# UNITED STATES PATENT AND TRADEMARK OFFICE

| APPLICATION NO. | FILING DATE | FIRST NAMED INVENTOR | ATTORNEY DOCKET NO. | CONFIRMATION NO. |
|-----------------|-------------|----------------------|---------------------|------------------|
| 10/810,288      | 03/26/2004  | Andre Timmermans     | 02581-P0562A        | 9283             |

| <b>Office Action Summary</b> | <b>Application No.</b><br>10/810,288   | <b>Applicant(s)</b><br>TIMMERMANS ET AL. |  |

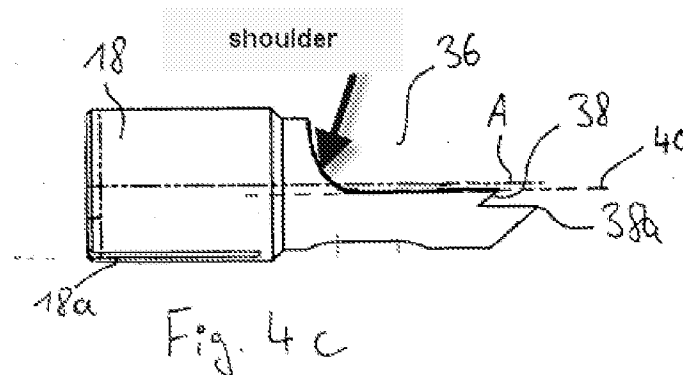
Claims 1-31 are rejected under 35 U.S.C. 103(a) as being unpatentable over Stryker Leibinger (DE 201 05 590 U1) in view of Clark (US Patent 5,954,747). Stryker Leibinger discloses a device for inserting a suture anchor (such as a drill component or a connecting component) having a hollow guide sleeve (16) through which a suture thread anchor may be passed, a distal end of a guide sleeve having a front annular face (36), and wherein the guide sleeve comprises a point projecting distally from the front annular face of the guide sleeve, and wherein a shoulder is formed between the distally projecting point and the remaining part of the annular face. See drawing below.

It is further noted that the shoulder is considered to extend in a cross section plane and is substantially perpendicular to a longitudinal axis of a guide sleeve (A).

Stryker Leibinger disclose the claimed invention except for a guide sleeve comprising a single point, compared to the multiple points shown above. Clark discloses a bone anchor system that has a guide sleeve with one point extending from the distal end (see Fig. 3). It would have been obvious to one having ordinary skill in the art at the time the invention was made to construct the device of Stryker Leibinger having at least a single point projecting distally, as this construction would be beneficial in contacting the bone surface for optimum positioning of the suture anchor.
